SMCCCD - District Office

Access Compliance Survey Report

District Office (CSM)

SSA Project #: 19029.00

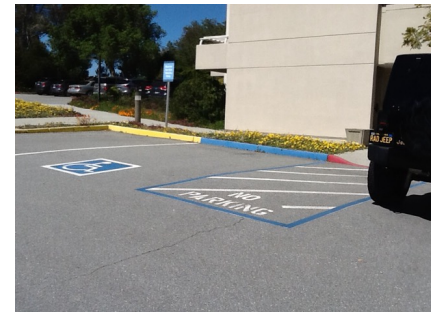
At parking lot with 51-75 spaces, the number of accessible spaces is less than required by code; 3 spaces required.

• *As-Built:* **1 accessible. Need 3 total.**• *Proposed Solution:*

Provide required accessible parking spaces with signs including a minimum of one van space.

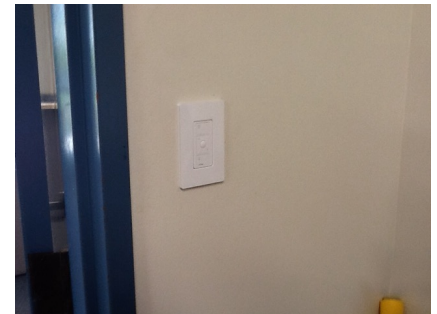
Electric switch or control mounted less than 15" measured to the bottom of the outlet box or greater than 48 inches measured to the top of the outlet box.

- *As-Built:* **53" AFF**

Relocate light switches or control to between 15" and 48" height.

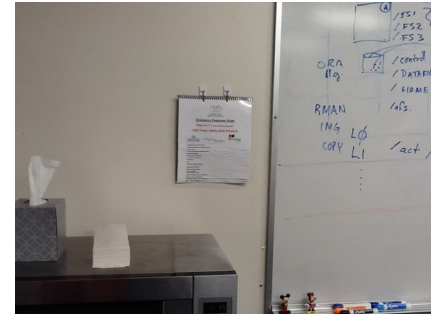
Reach height to control or access point, exceeds 48" or is less than 15".

• *As-Built:* **53" AFF**• *Proposed Solution:*

Modify equipment or mounting.

96

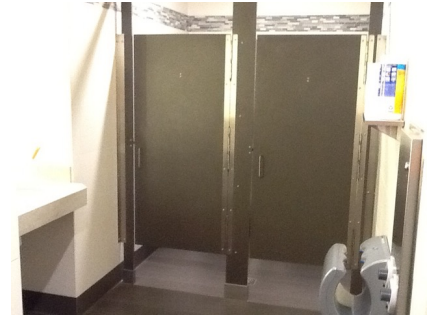
• *As-Built Description:*Multiple accommodation restroom not accessible;
multiple compliance violations.• *Proposed Solution:*Remodel area to provide accessible restroom with
one accessible stall, lavatory (and one urinal at
Mens).

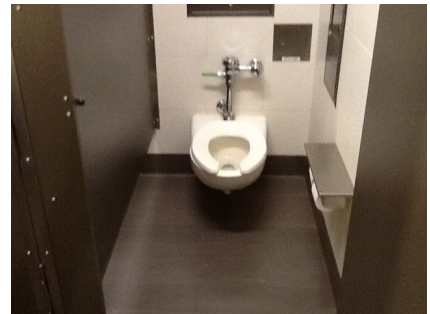
Toilet stall less than 60" wide.

Provide new accessible stall

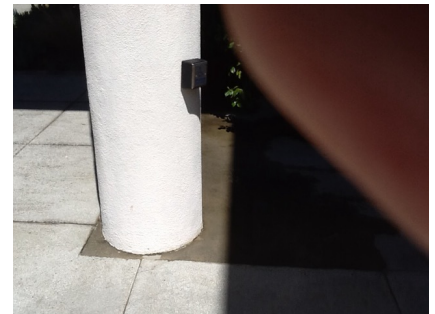
High push plate located at 30" minimum and 44" maximum above the floor or ground surface not provided.

• **Notes:****No lowered button**

Provide higher push plate.

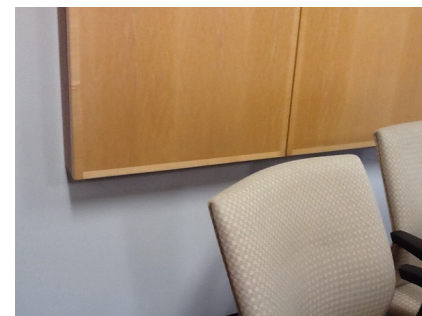
Protruding objects more than 4" from wall, when bottom of object more than 27" or less than 80" above finished floor.

• *As-Built:* **Cabinet 6" protrusion at 35" high.**

Provide cane-detectable railing to mark area of low clearance.

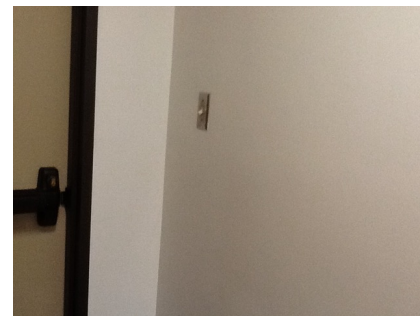
Electric switch or control mounted less than 15" measured to the bottom of the outlet box or greater than 48 inches measured to the top of the outlet box.

• *As-Built:* **54" AFF**• *Proposed Solution:*

Relocate light switches or control to between 15" and 48" height.

154

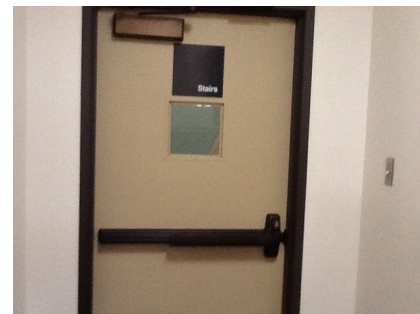
Vision Light at door that permits viewing, does not have bottom of at least one glazed panel located 43 inches maximum above the finish floor. (Exception: More than 66" above finished floor.)

• *As-Built:* **54.5" AFF**• *Proposed Solution:*

Provide new door with vision panel at 43" max.

158

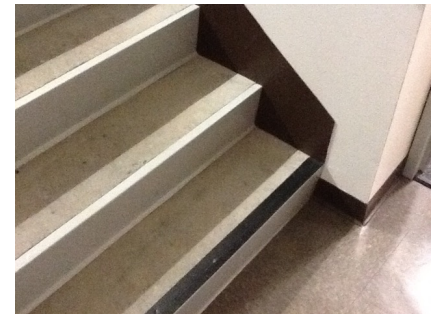
• *As-Built Description:*The leading 2" of the tread does not have visual
contrast of dark-on-light or light-on-dark from the
remainder of the tread.• *Proposed Solution:*Provide 2" min., 4" max. wide contrasting color
strip 1" max. from nosing on top & bottom treads
when altering area.

173

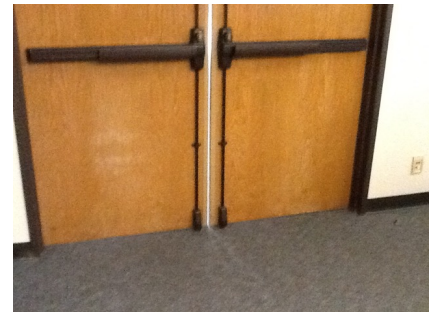
At push side of door on accessible route, bottom 10" does not have a smooth, uninterrupted surface.

Provide 10" min. "kick plate" covering width of door when altering area.

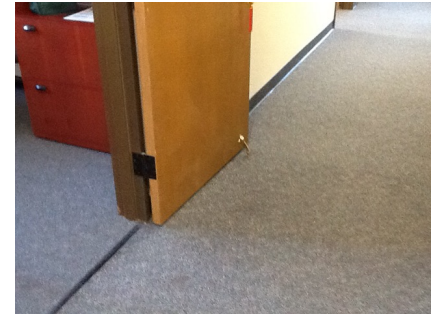
At push side of door on accessible route, bottom 10" does not have a smooth, uninterrupted surface.

Remove door stopper when altering area. Provide rubber wedge.

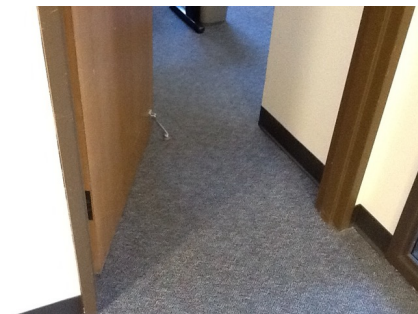
At push side of door on accessible route, bottom 10" does not have a smooth, uninterrupted surface.

Remove door stopper when altering area. Provide rubber wedge.

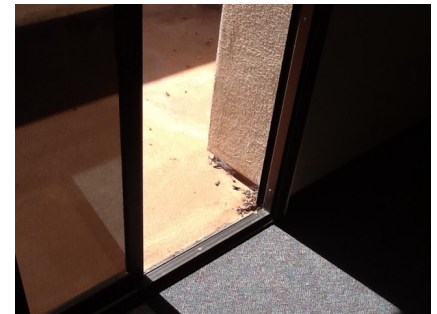
- *As-Built:* **12 lbs.**

Adjust regular door closer to accessible standards (5 lbs. max).
